Contract #: 04-0120F4Cty: SF/ALA Rte: 80 PM: 13.2/13.9File #: 69.25B**QUALITY ASSURANCE -- NON-CONFORMANCE REPORT****Location:** Changxing Island, Shanghai, PRC**Report No:** NCR-000092**Prime Contractor:** American Bridge/Fluor Enterprises, a JV**Date:** 20-Mar-2008**Submitting Contractor:** Zhenhua Port Machinery Company, Ltd (ZPMC), Changxing Island**NCR #:** ZPMC-0090**Type of problem:**

Job Name: SAS Superstructure

Subject: NCR No. ZPMC-0090

Reference Description: Tower Diaphragm 28/38 Meter / Heat Straightening - Active Force Applied

HSR1(T)-0152

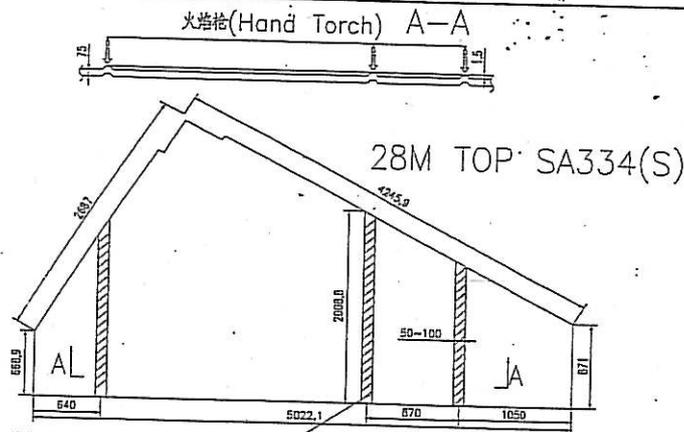
校火区域: 此板最大变形量约1.5mm

Flame straightening area: the max deformation is about 1.5mm

纵向: 最大校火长度约2008.8mm, 宽度50~100mm

Longitudinal: the max length is about 2008.8mm, the width is 50~100mm

Production material will be straightened by mechanical means

HSR1(T)-188

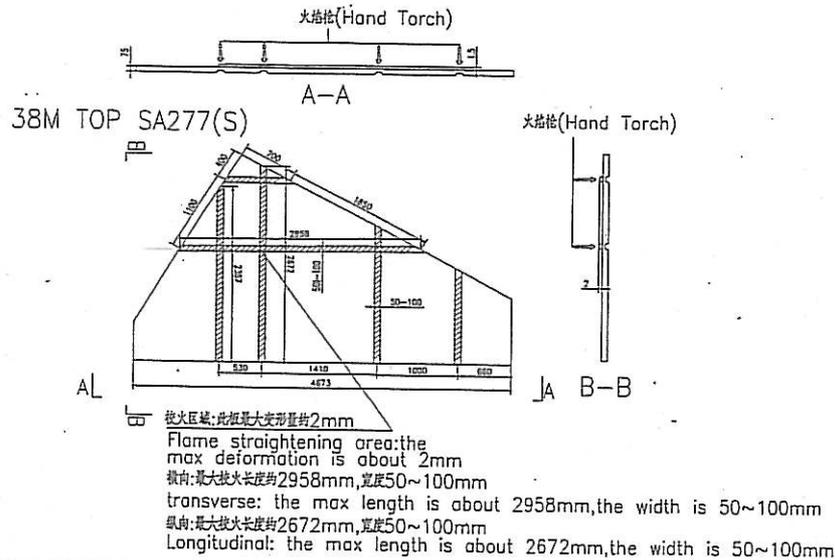
ABF has allowed ZPMC to utilize active force while heat straightening (HS) diaphragm plates observed on 19-MAR-08 and 20-MAR-08. The manner in which the ABF/ZPMC used the counter weights is not an acceptable practice and was not included as part of the ABF/ZPMC approved Distortion Control Plan or Heat Straightening Reports for the following Tower Diaphragm plates: (1) 28 Meter bottom SA270(S) ZPMC (HS) Report Number HSR1(T)-197, (2) 28 Meter top SA334(S), ZPMC (HS) Report Number HSR1(T)-197, (3) 38 Meter top SA227(S), ZPMC (HS) Report Number HSR1(T)-188.

纠正措施(Corrective Action(s)): Production material will be straightened by mechanical means
